PLANNING APPLICATION NK/2024/0338

Proposal: Outline planning permission for the erection of up to 58 dwellings

North Northamptonshire Green Party (NNGP) OBJECT

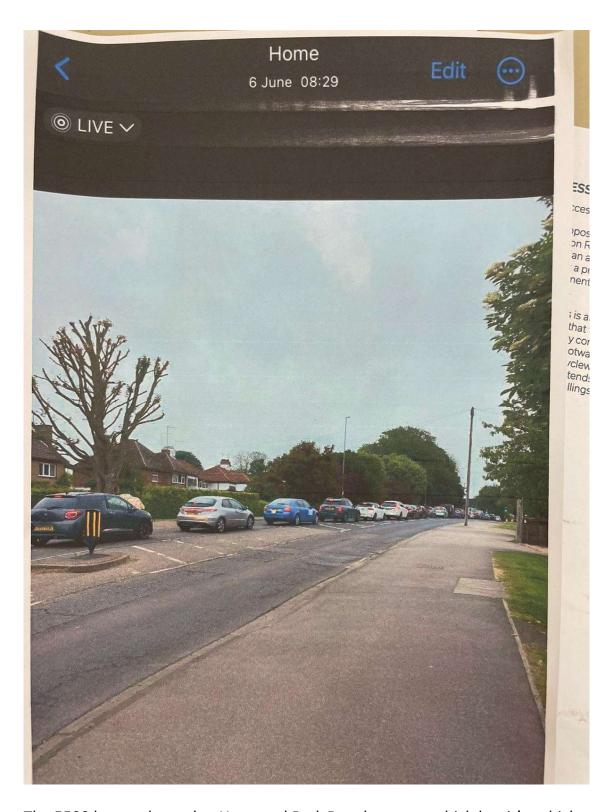
Photographic images of Barton Road at the proposed junction to the site clearly shows queuing traffic at this point, which contradicts the findings of the MAC Report. As the picture below shows, and other anecdotal reports from users of the road suggest, a problem at the proposed junction is likely to arise.
